**APPLICATION  
FOR PERCOLATION TESTING AND SITE EVALUATION**

**From:** Silvast, Zackary  
**Sent:** Monday, January 31, 2022 11:42 AM  
**To:** frank.white@kci.com  
**Cc:** Askariza79@gmail.com; Williams, Jeffrey  
**Subject:** OSDS comments for 14945 Old Frederick Road (EH-PLANS-22-0011)  
**Attachments:** 14945 updated specs.pdf; 14945 perc cert 1.pdf; 14945 perc cert 2.pdf

**From:** Silvast, Zackary  
**Sent:** Tuesday, November 29, 2022 4:42 PM  
**To:** 'Frank White'  
**Cc:** Williams, Jeffrey; 'Jacob Leimbach'  
**Subject:** regarding 14945 Old Frederick Road PC & OSDS plans (BP# - B22001367)

**LOT 5, RIZVI PROPERTY**  
**ON-SITE SEWAGE DISPOSAL SYSTEM DESIGN PLAN**  
14945 OLD FREDERICK ROAD  
WOODBINE, MD 21797  
TAX#: 348885, SUB: 1001

**LOT 5, RIZVI PROPERTY**  
**ON-SITE SEWAGE DISPOSAL SYSTEM DESIGN PLAN**  
14945 OLD FREDERICK ROAD  
WOODBINE, MD 21797  
TAX#: 348885, SUB: 1001

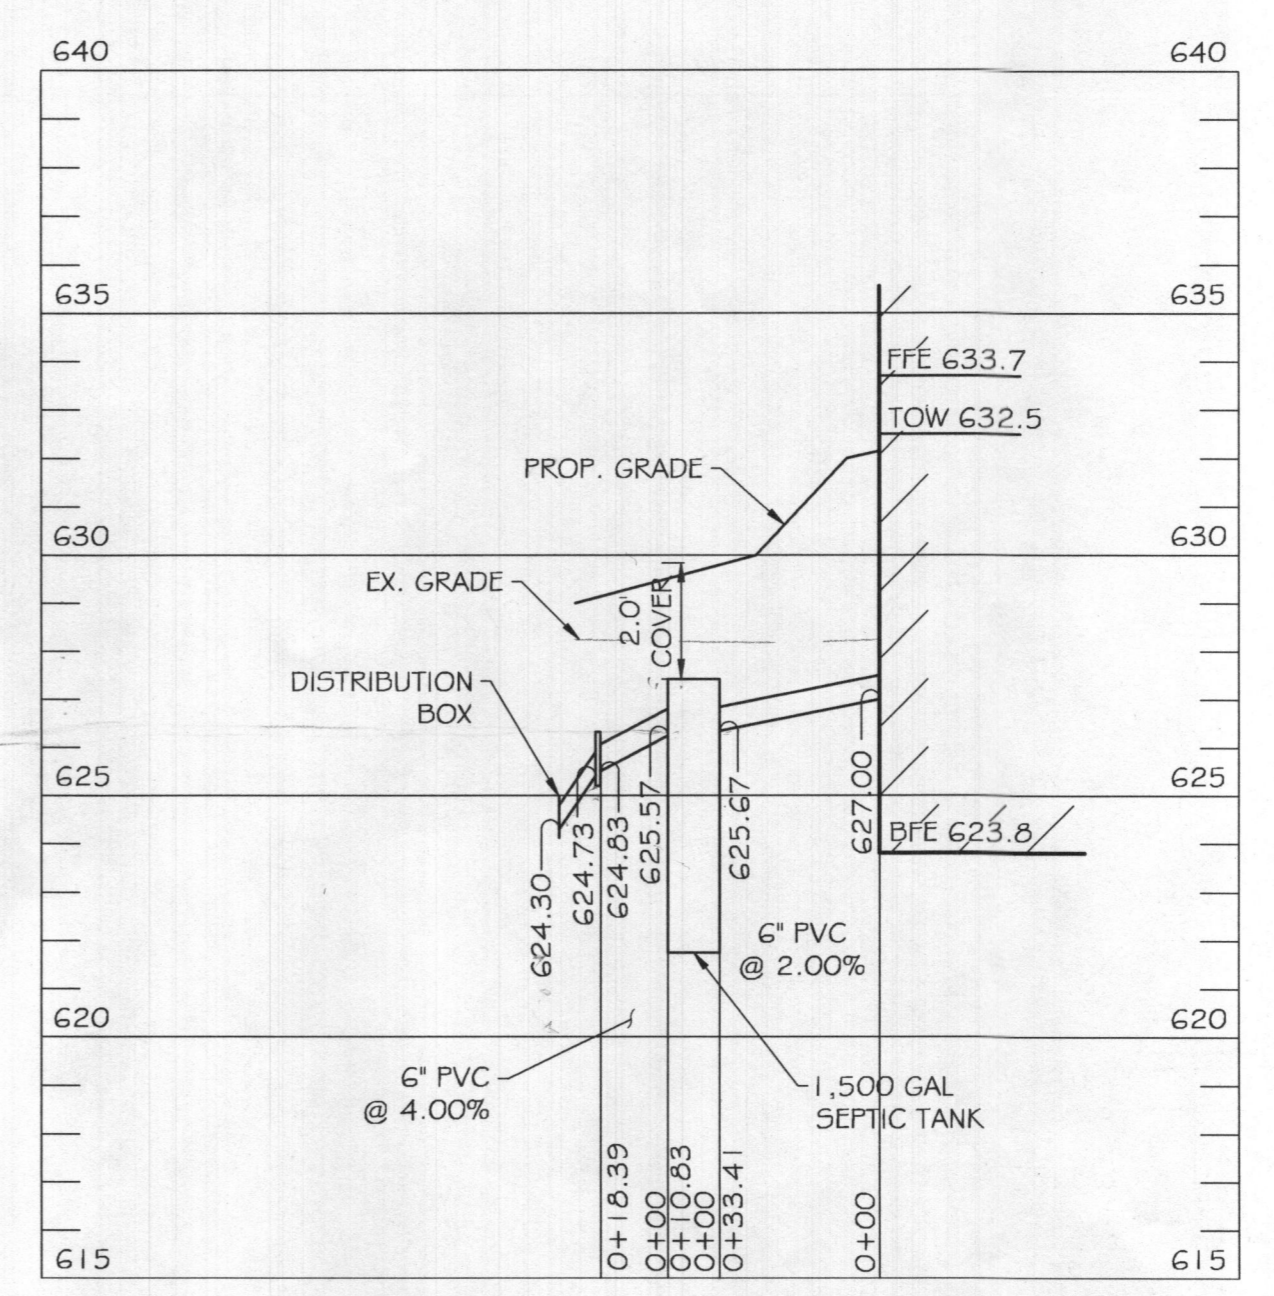
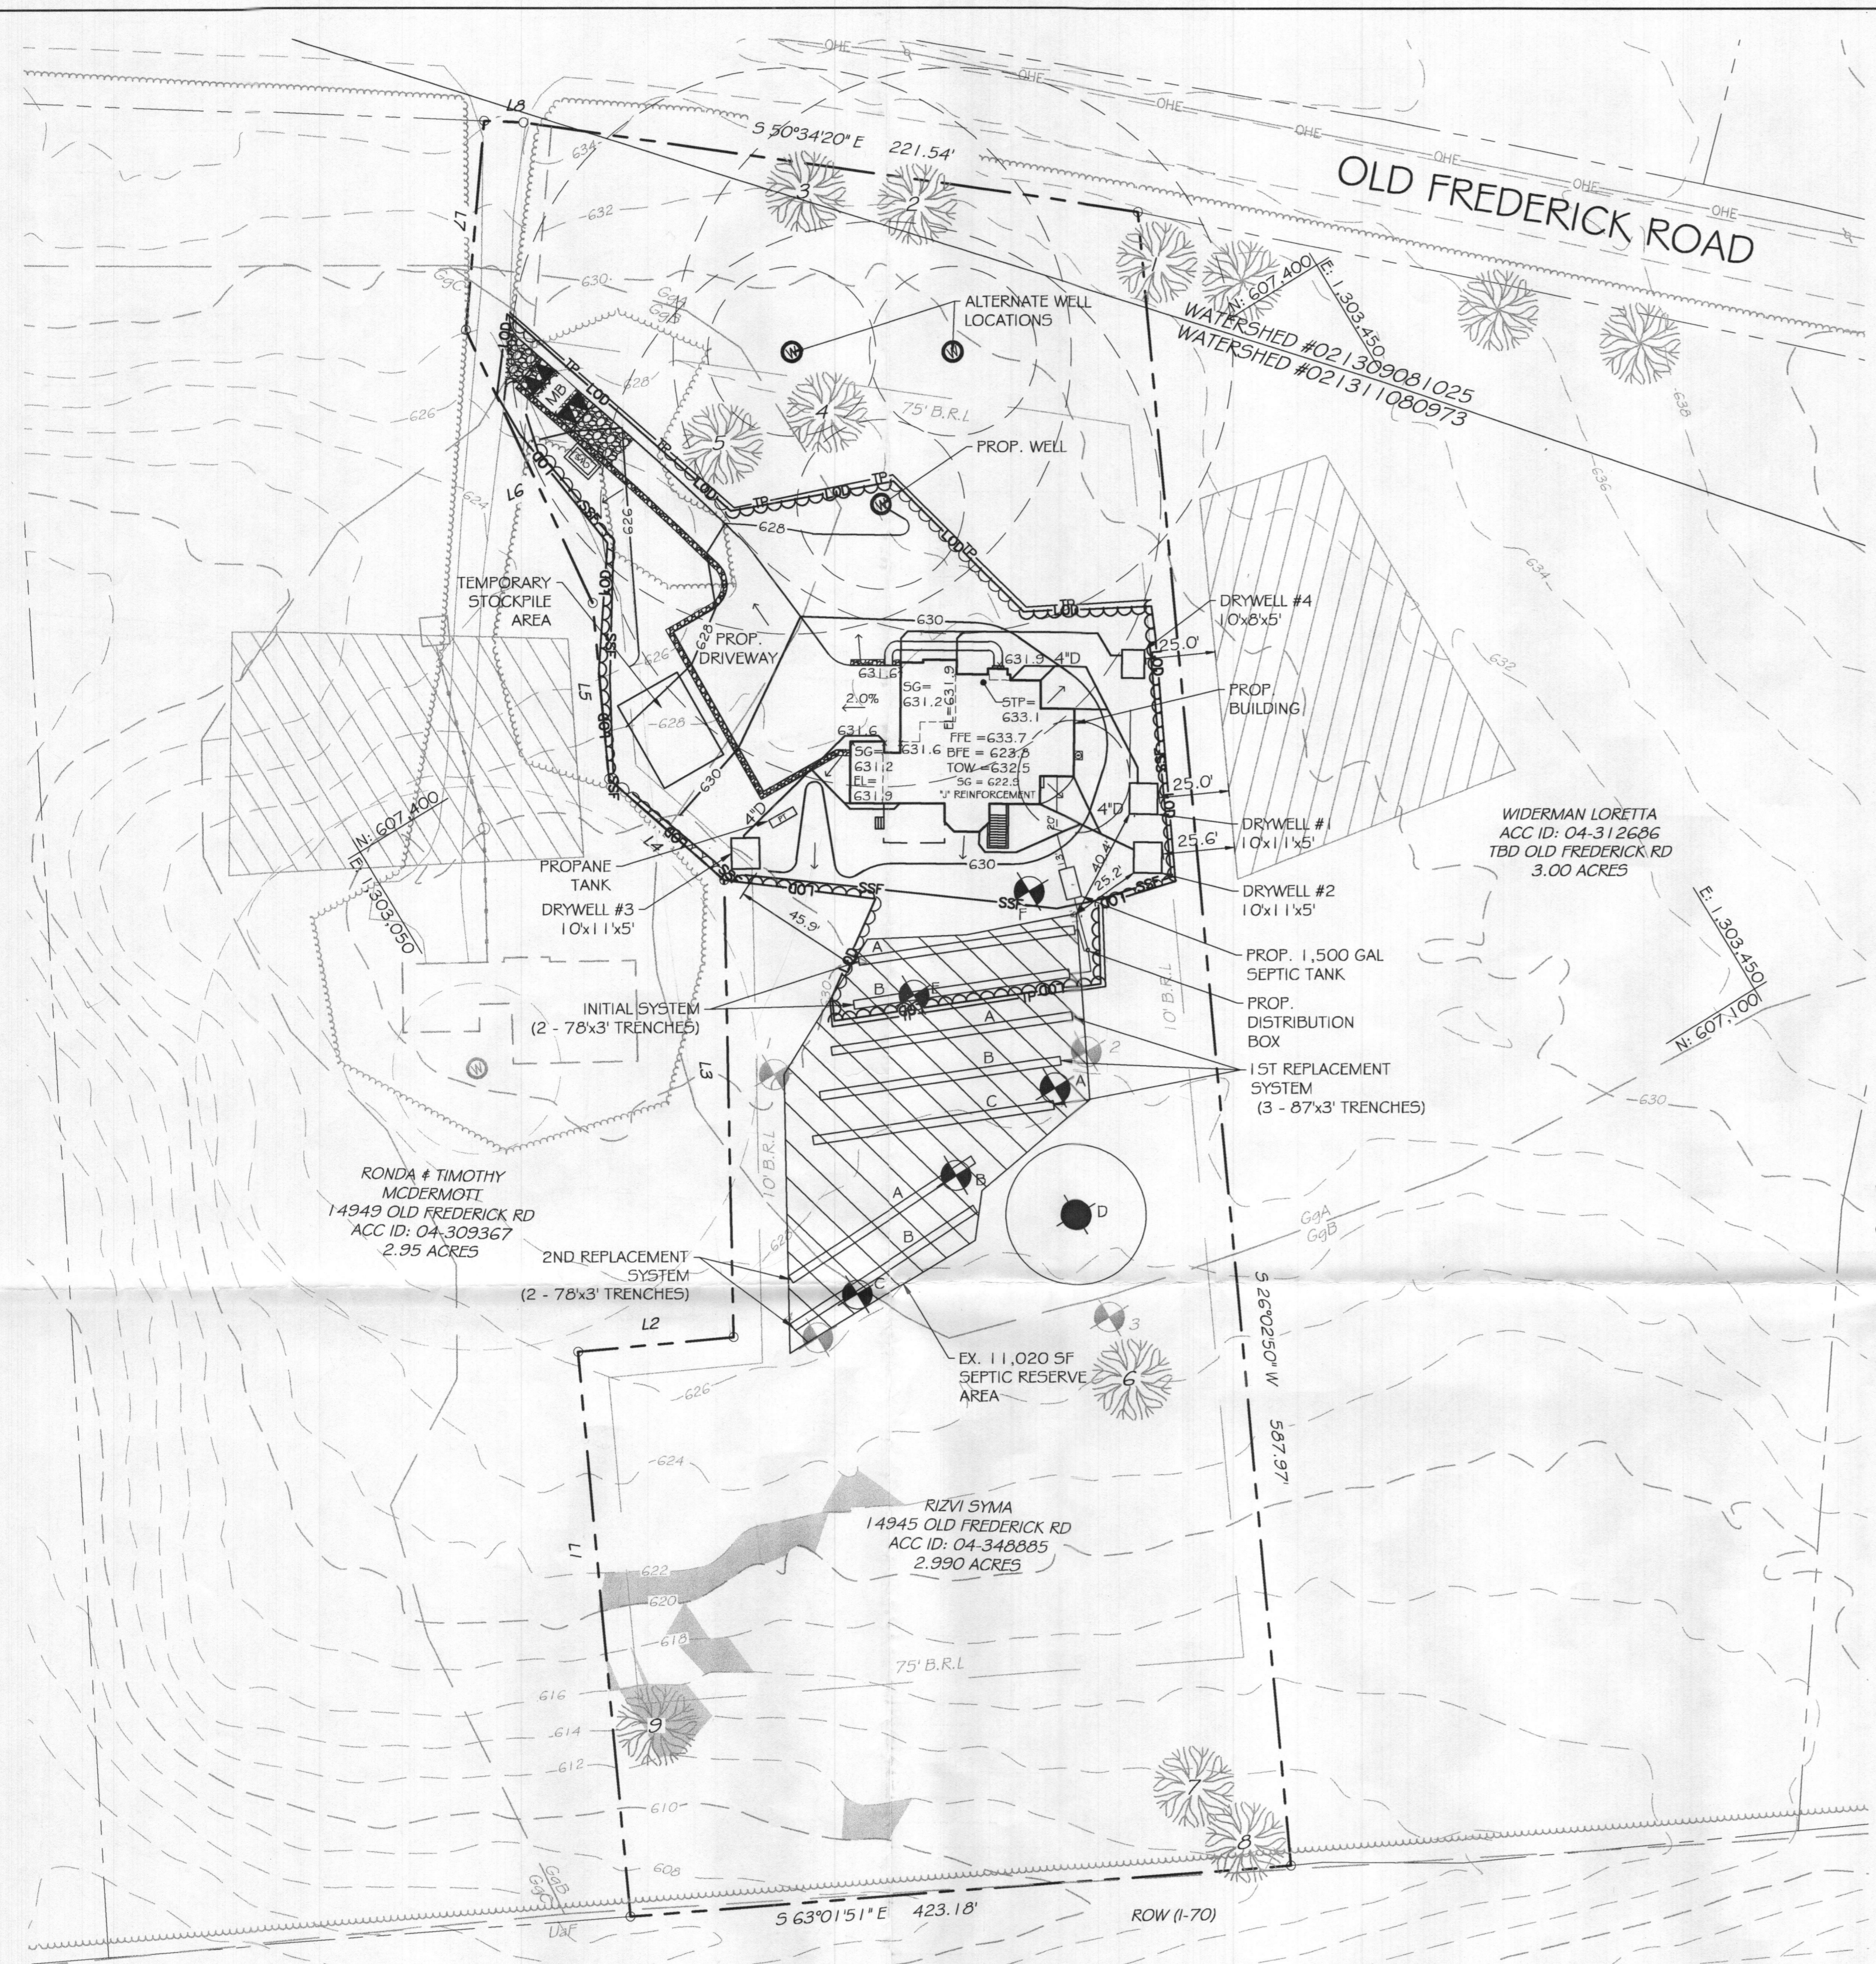
Need more on contour

maybe shoot 1' contours and  
end elevations  
on trenches

**EX. SEPTIC SYSTEM PROFILE**  
SCALE: H. 1" = 4'  
V. 1" = 4'

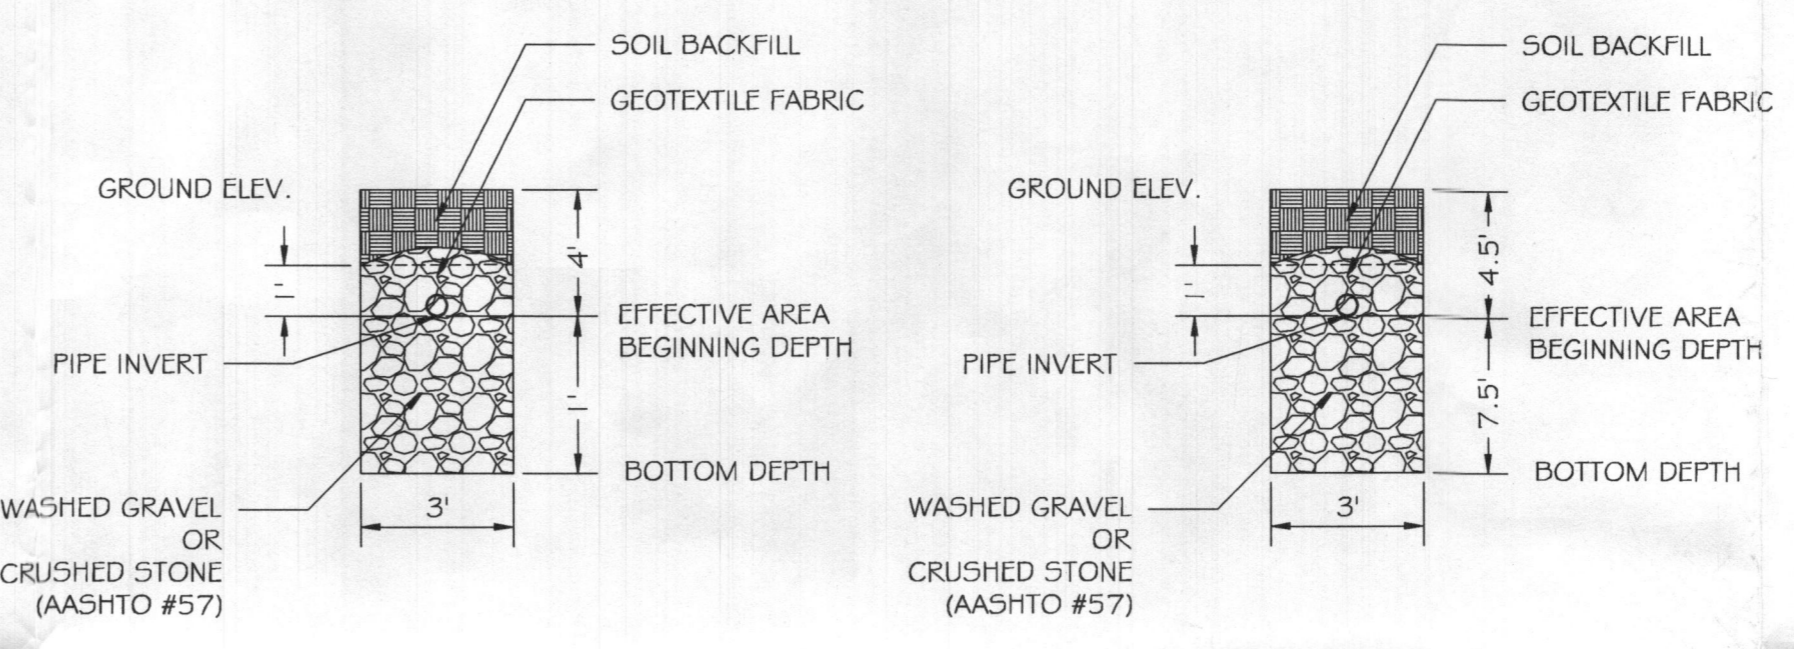
1. **The septic system profile numbers appear to be off by a foot. We have ground at 629.57' elevation then 2' of cover so we'd be at 627.57' but the pipe leaving the tank is at 625.57'. \*\*\***
  - a. **This has forced the distribution box to be deeper than it needs to be. (can only be 4' deep max, regardless)**
  - b. **This has also forced the trench pipe inverts below ground to be too deep.**
  - c. **We will need all new numbers for the elevation profile. \*\*\***
2. **The other thing we would change is to make sure that no pipe inverts go deeper than 4'. That is a maximum depth. Currently, the initial system & the 2<sup>nd</sup> replacement system has proposed pipe inverts that are deeper than 4'. \*\*\***
3. **There is one error with the trench design which is also easily fixable (5 bedrooms X 150 GPD) should be 750 GPD not 600 GPD. (this I have already fixed on all plans)**
